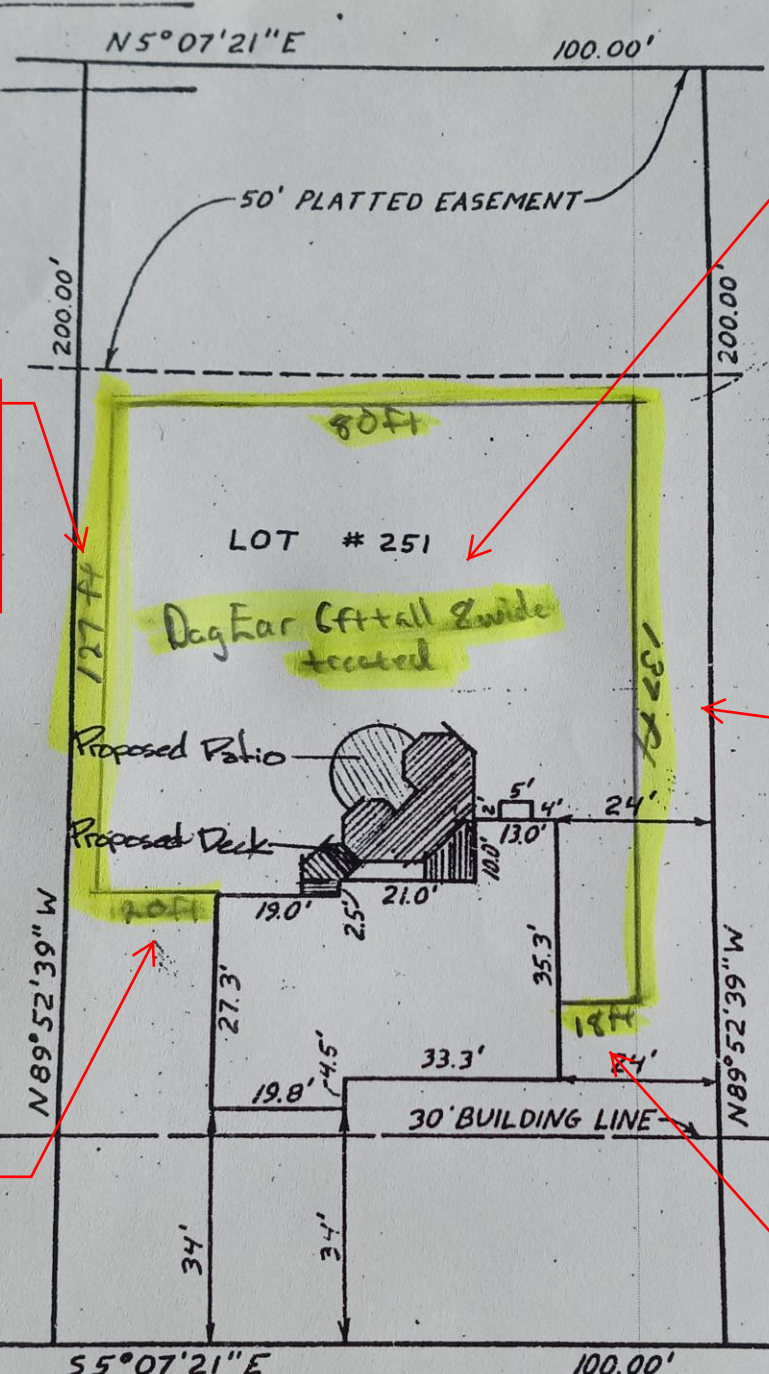
Maximum permitted dimension is 88-feet in order to not be in platted easement

Fence may have maximum height of 4-feet and must be 50% open or see through

Dimension will need to be updated based on the other dimensions

Maximum permitted dimension is 12 feet in order to meet side yard setback requirement

Maximum permitted dimension is 14-feet in order to meet side yard setback requirement
